ALERT SERVICE BULLETIN

UH-1H-16-15

MODEL AFFECTED: UH-1H

SUBJECT: ASSIGNMENT OF A 3,300 HOUR RETIREMENT LIFE AND RE-IDENTIFICATION OF SCISSORS LEVER ASSEMBLIES P/N 212-010-407-001 AND -109; AND, ASSIGNMENT OF A 1,000 HOUR RETIREMENT LIMIT ON P/N 212-010-411-005 BOLT INSTALLED ON THE UH-1H HELICOPTER

FIGURE 1

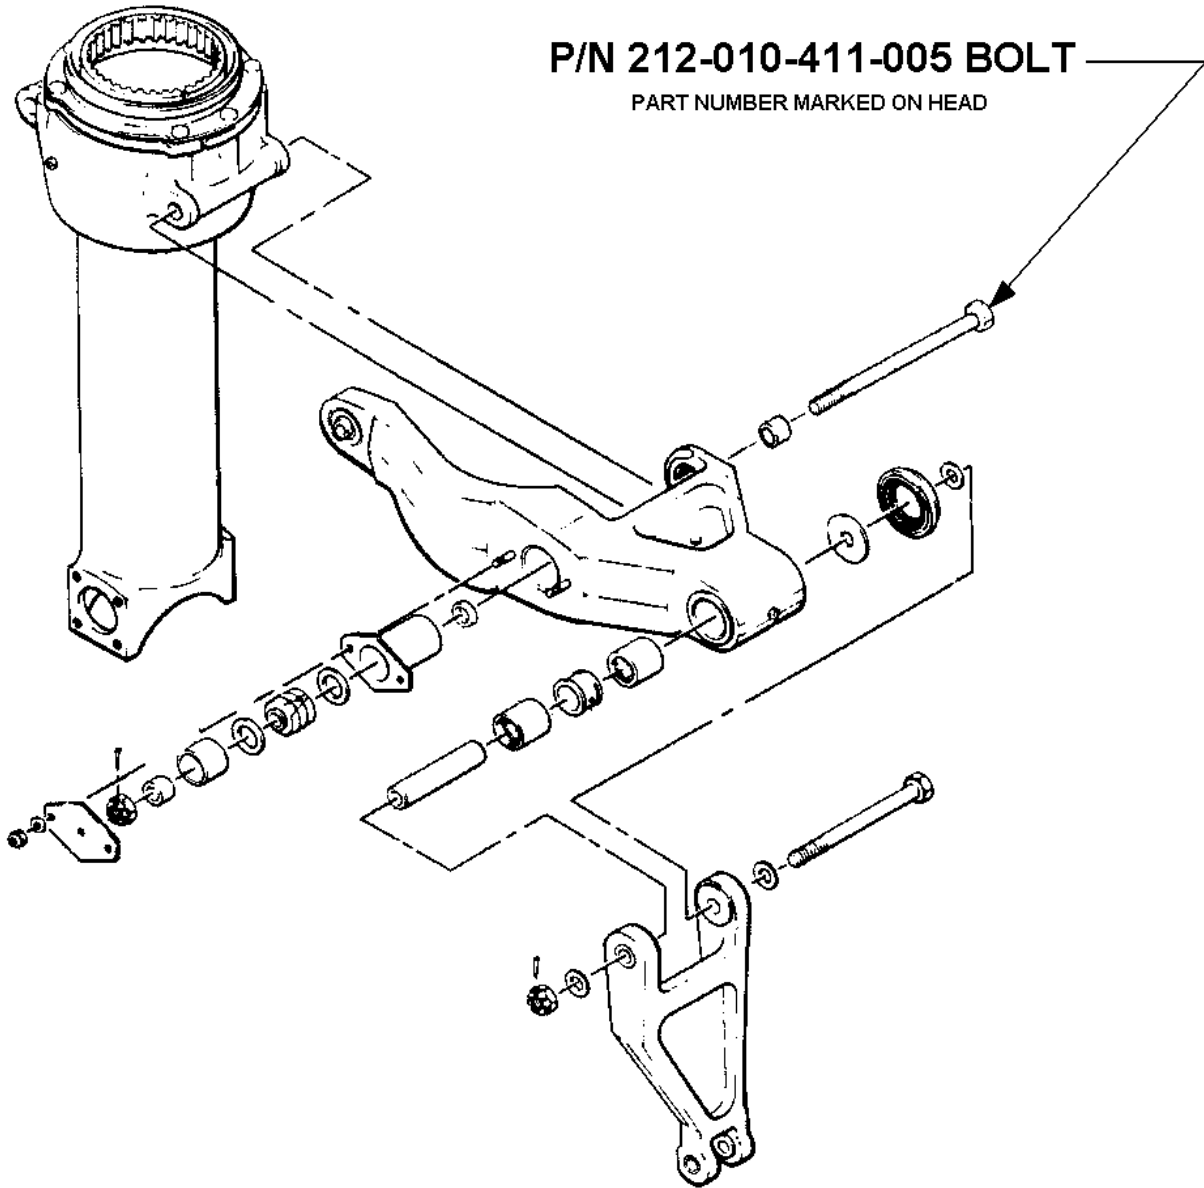
2. Inspect each scissor and sleeve assembly with P/N 212-010-407 scissor lever assemblies installed to determine part number of the installed pivot bolts (Figure 1).

- a. If a bolt with a part number other than P/N 212-010-411-005, or whose part number cannot be determined, is found installed, it must be removed from service within the next 50 flight hours, but not later than six months, following receipt of this ASB. Refer to Technical Bulletin SU-94-1, Revision B, Accomplishment Instructions, PART III, for bolt removal and installation and record procedures for the P/N 212-010-411-005 bolt.

- b. For each installed P/N 212-010-411-005 pivot bolt, review pertinent helicopter/component records to determine its current total time.
 - 1) P/N 212-010-411-005 bolts with a current total time in excess of 1,000 hours, or whose total flight time cannot be determined, must be removed from service within the next 50 flight hours, but not later than six months, following receipt of this ASB. Refer to Technical Bulletin SU-94-1, Revision B, Accomplishment Instructions, PART III, for removal and installation procedures for the -005 bolt.

- 2) P/N 212-010-411-005 bolts whose current total time can be documented as less than 1,000 hours may be retained in service.
 - a) If not previously accomplished, create an historical record card (HRC) for each -005 bolt indicating a retirement life of 1,000 hours and annotate the bolt's documented current total time.

- b) Revise scissors and sleeve assembly historical records as required to add the -005 bolt and its 1,000 hour retirement life.
